**EXPERION PKS**  
**RELEASE 511.3**

**Software Change Notice**

EPDOC-X166-en-5113F

November 2020

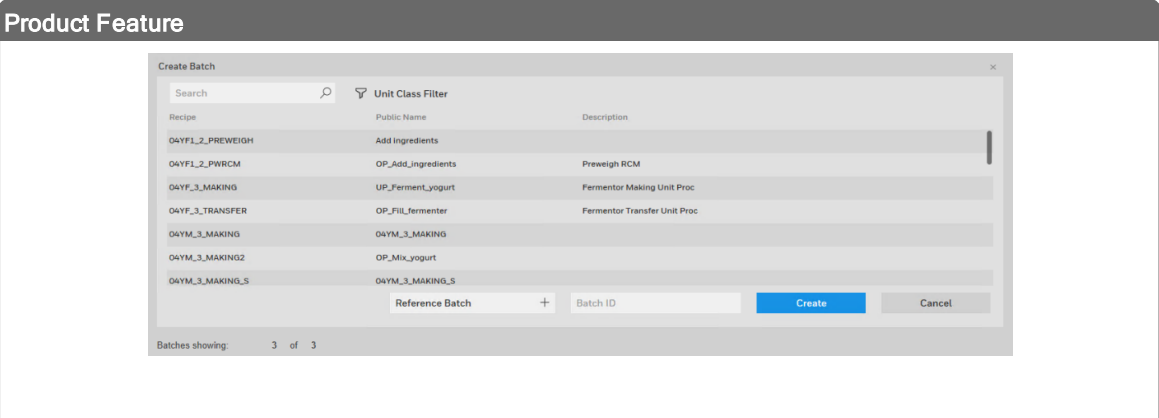
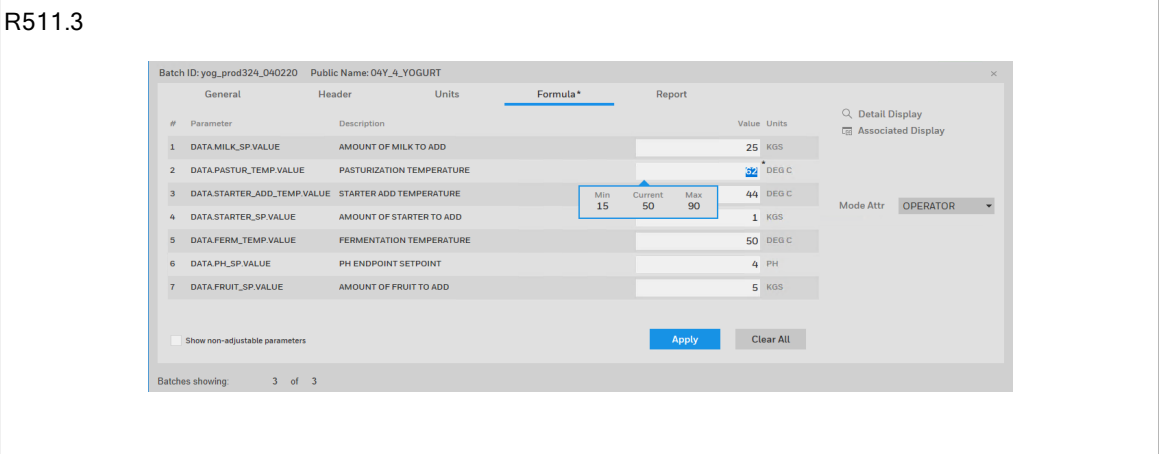
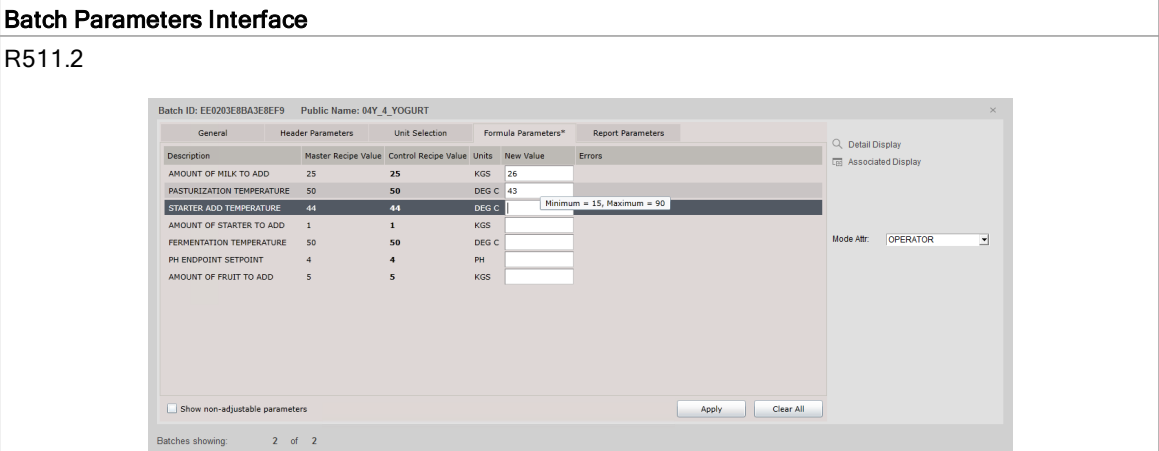
- Changes:**
- To better support workflow and simplify the display:
- The **Batch ID** and **Reference Batch** list have been moved to the bottom.
  - The **Asset Filter** has been removed. Assets can be selected from the **Location Pane** in the relevant **Summary** display.
  - The **Unit Class** filter has been moved to the top, and while differently styled still functions in the same way.
  - **Recipe** and **Public Name** filter functionality has been incorporated into the **Search** field at the top of the pane. Search criteria now also searches text in the **Description** column.
  - The appearance of the Create Batch interface now matches the currently selected Station theme (classic, light, dark).

## Product Feature

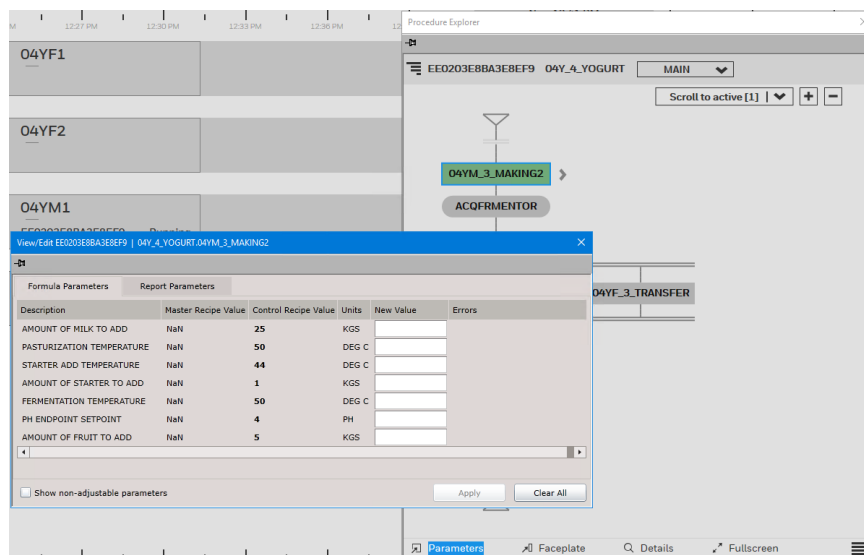
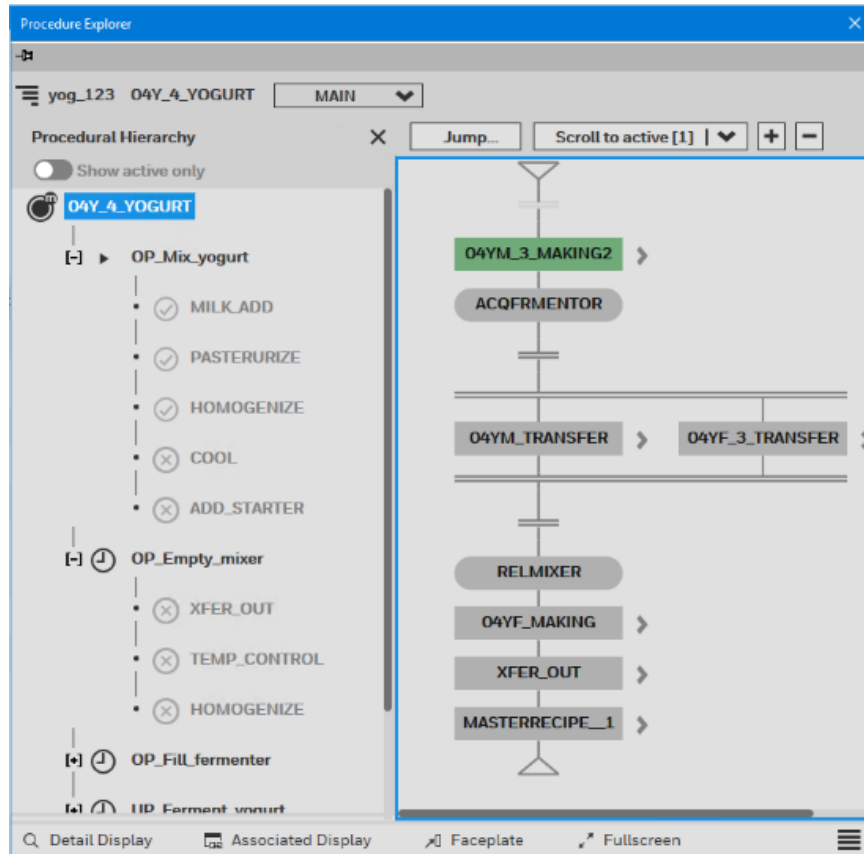
### Changes:

To better support workflow and improve usability:

- Asterisks on the tab and beside a changed value indicates an unsaved change.
- The **Errors** column has been removed. An error icon beside the parameter name indicates an error applying the new value. A callout on the error icon displays the error details.

- The **Master Recipe Value** column has been removed in the default view. To show this column, select the **Show master recipe value column in batch parameters** check box on the Summary displays tab of the Server Wide Settings display.

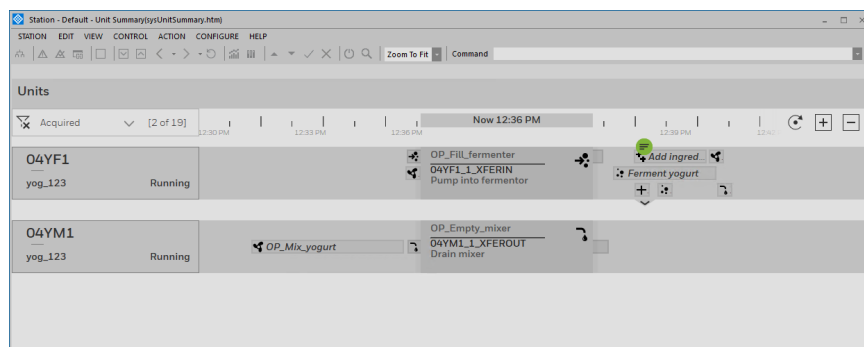
To better support workflow and improve usability:

- The Parameter details have been added to the Procedure Explorer details pane. You can display the Details pane by clicking the menu icon in the bottom right corner of the Procedure Explorer.
- The Parameters link at the bottom of the Procedure Explorer replaced with Associated Display as it is now redundant.
- Procedure Explorer functionality enhancements allow the users to view and interact with future, not yet executed procedural elements of a selected batch using Procedure Explorer chart and tree view. Using the Procedure Explorer, an operator can watch the entire hierarchy except for the completed procedural elements of a selected batch.
